AMSAFE AVIATION INFLATABLE RESTRAINTS

SERVICE LETTER 25-031

Change in life limit for inflators used in AAIR (AmSafe Aviation Inflatable Restraint) systems used on part 23 and 25 aircraft.

ENGINEERING ORDER

Figure 2. Sample Label showing revised inflator life limits

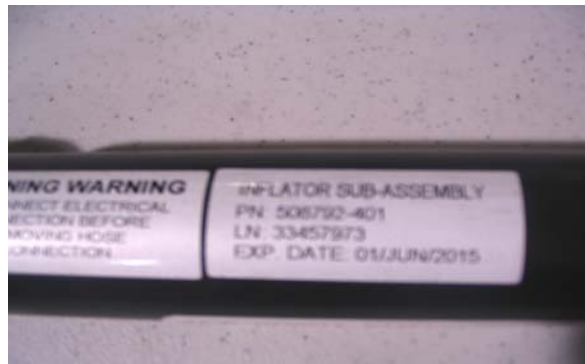
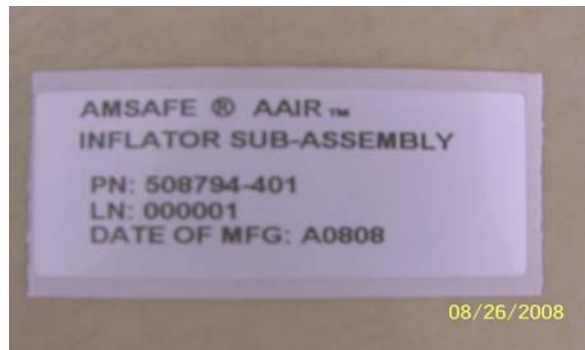
The FAA recently approved a change in the inflator life limits from 7 to 10 years. Previously the inflators were approved for a maximum life (service/storage) of 14 years with a 7 year refurbishment required by AmSafe Aviation. The approved change allows a maximum combined service/storage life of 10 years (from date of manufacture) with no required refurbishment. The Instructions for Continued Airworthiness are currently being revised to reflect this change.

Authorized personnel using the AAIR system should update their records/maintenance program to reflect the above noted changes. Prior to the approved change, each inflator had an AmSafe Aviation "Inflator Sub-Assembly" label which included the AmSafe part number, lot number, and expiration date. The 10 year life limit of an inflator with an expiration date, as shown in Figure 1, can be determined by adding three (3) years to the expiration date. If the inflator has an AmSafe label stating the "date of mfg" (see Figure 2), the service life of the inflator is 10 years after the "date of mfg".
